LINKS ROAD EXTENSION AND UPGRADE, ST MARYS CONCEPT DESIGN REPORT

NOVEMBER 2018

Links Road Extension and Upgrade, St Marys Concept Design Report

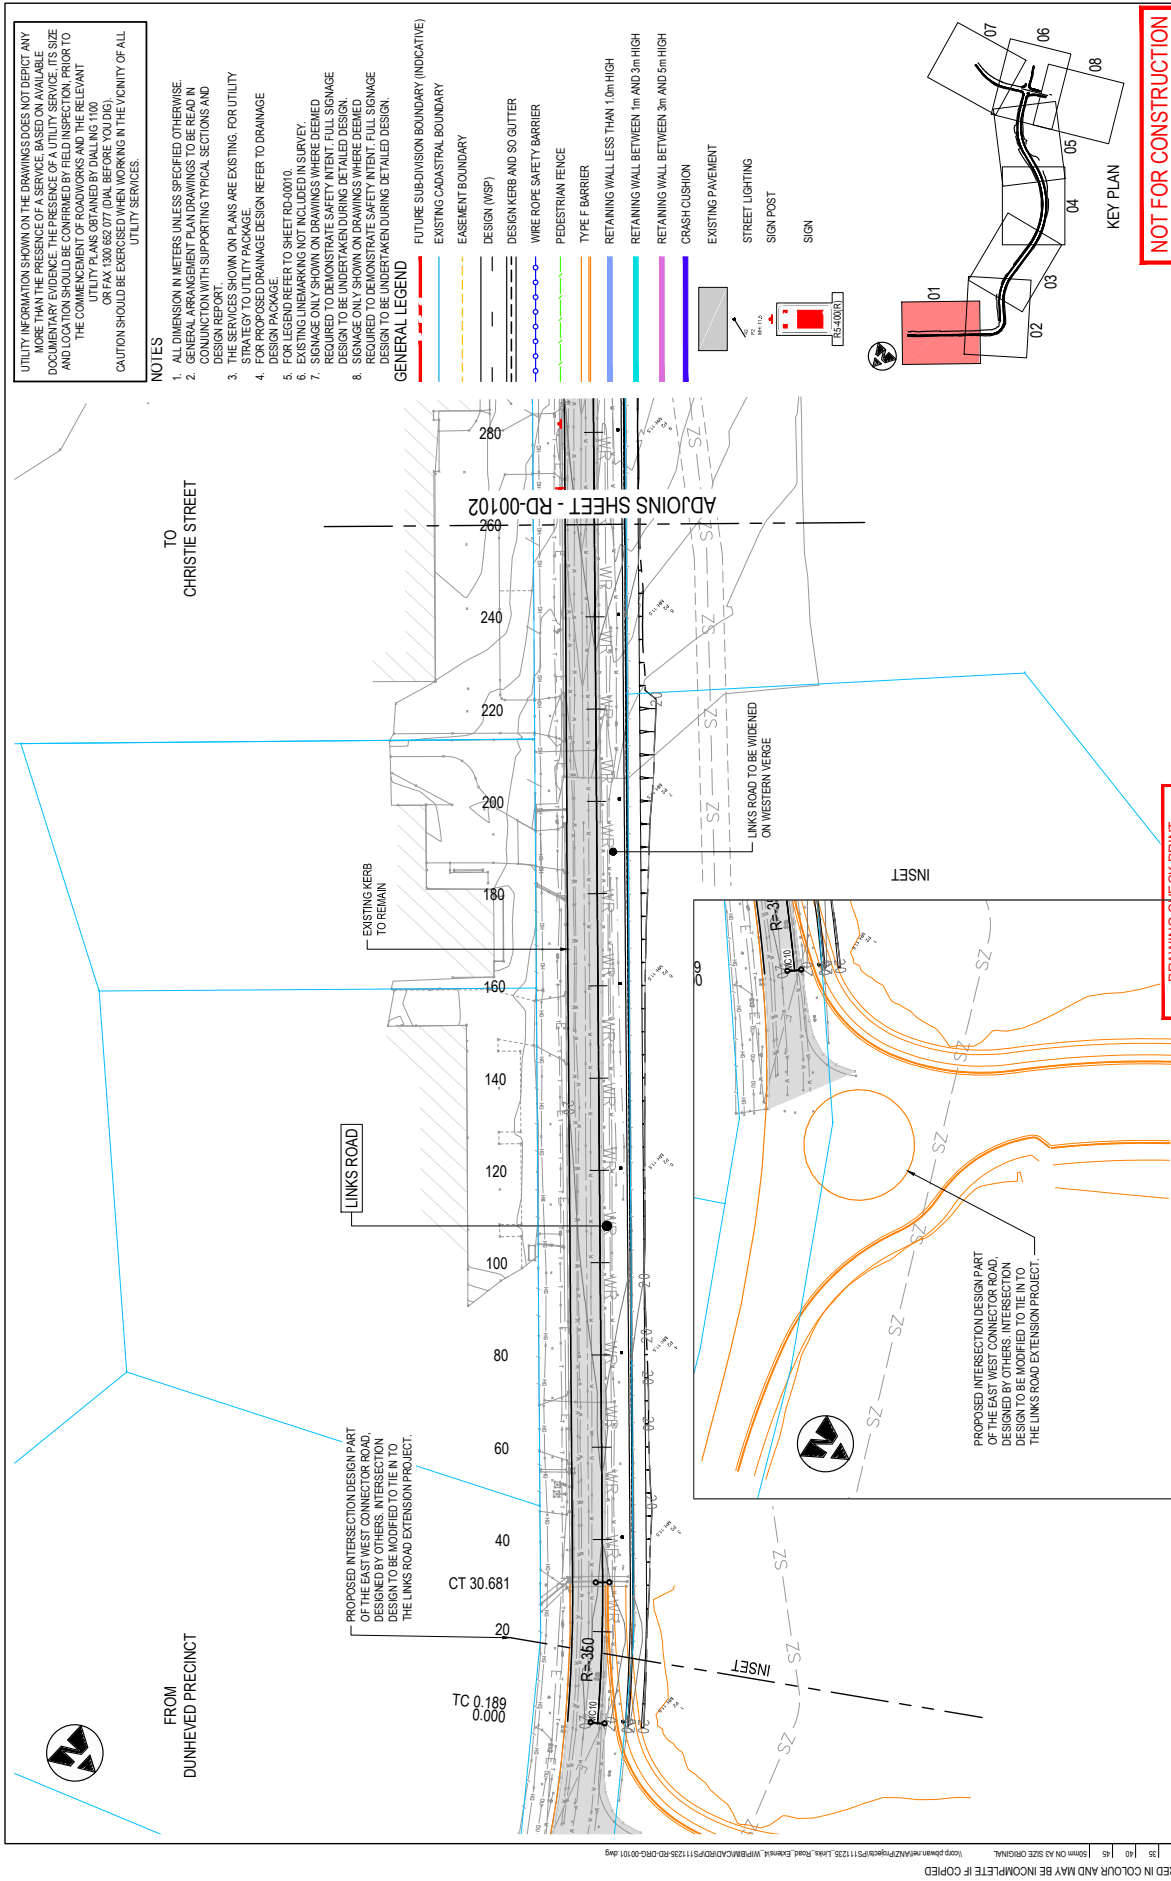
- At Approx. CH 380 (RD-00102) Two existing driveways are located at the outer alignment of the 90-degree bend which provide access to the Sydney Water pump station.

The tabled Stormwater management plans do not indicate central median collection of water run-off that would occur across the pavement of the EB carriageway at the eastern end of median.

Consideration should be given to collecting water run-off at the end of median to eliminate the potential of aquaplaning.

Given the content of HVs in the traffic stream consideration should be given to employing "Tilting Truck" signs (W1-8B), in both directions, supporting the 35 Km/hr advisory speed signs, displayed in correct orientation.

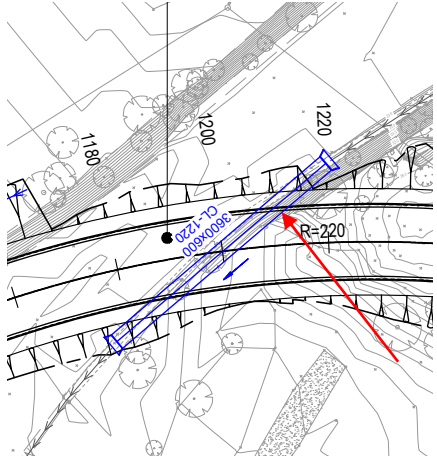
Item No.	Location	Description of Risk	Detail	Priority (L/M/H)	Accept/Reject	Response
10	At Approx. CH 380 RD-00102	<p>The road alignment comprises a 90-degree curve. Warning signs such as hazard markers are not provided to indicate the curve. This could result in drivers not recognising the road alignment ahead, particularly in dark or wet conditions.</p> <p>Apart from the 35 km/hr advisory speed signs, no other signs or traffic calming treatments are provided prior or at the bend.</p> <p>Vehicles in particular heavy vehicles travelling in excessive speed through this bend may have the potential to lose control and HVs to tilt over.</p> <p>Given the content of HVs in the traffic stream consideration should be given to employing "Tilting Truck" signs (W1-8B), in both directions, supporting the 35 Km/hr advisory speed signs, displayed in correct orientation.</p>		H	A	<p>Design has been conducted to achieve a 35km/h design speed for heavy vehicles around the bend. This uses 6.0% superelevation, which is in excess of Austroads recommendations. This is outlined in detail in the Design Report.</p> <p>To be undertaken during Detailed Design and incorporate Council engagement, review and approvals process.</p> <p>This issue (supply of W1-8B) has been documented and escalated for resolution in next design phase.</p>

11	At Approx. CH 460 RD-00102 & RD-00103	<p>The horizontal alignment of the road between CH 340 and CH 580 employs a 39m radius LH curve followed by a 185m radius RH curve with a separation of 60m between tangent points of the curves.</p> <p>Concern is expressed that standards may need to be compromised to accommodate the road crossfall transition between the two curves.</p>		M	A	<p>Agreed. This has been raised during internal geometric QA processes. This is documented in the Design Report as an outstanding issue for resolution in next design phase.</p>

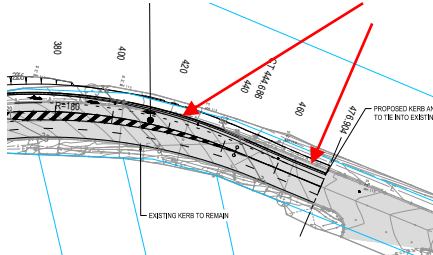
Item No.	Location	Description of Risk	Detail	Priority (L/M/H)	Accept/Reject	Response
12	At Golf Course Access CH 980 RD-00104	At the Golf Course access a central median and kerb have been employed in the access road. Kerb return radii to Links Road has not been shown. It is assumed that large vehicles will be required to service the Golf Club and on this basis appropriate radii serving an HRV should be considered.		M	A	Kerb returns have been determined using swept paths for 12.5m SU Truck for all movements, and are shown in the Design Report. Design can also cater for all a 14.5m Long Rigid Bus, excluding the left in movement. Consultation process during DA determination to confirm access arrangements for the golf course.
13	At Golf Course Access CH 980	The design includes a new T-intersection at the Golf Course. The Golf Course likely attracts a high volume of visitors who may not be familiar with the area and may not recognise the priority at the T-intersection due to the lack of signposting. Review of appropriate advance warning signs (lacking in the EB direction) and directional signposting should be considered for the final design.		M	A	Agreed. Signs and Linemarking design not undertaken as part of DA submission. This is documented in the Design Report as an outstanding issue for resolution in next design phase.

14	At Approx. CH 1200 SM 00105	The design indicates a substantial drainage structure crossing Links Road. Consideration might need to be given to employing guardrail protection for this culvert		H	A	Agreed. Road Furniture design not conducted as part of Concept Design DA submission. This is documented in the Design Report as an outstanding issue for resolution in next design phase.
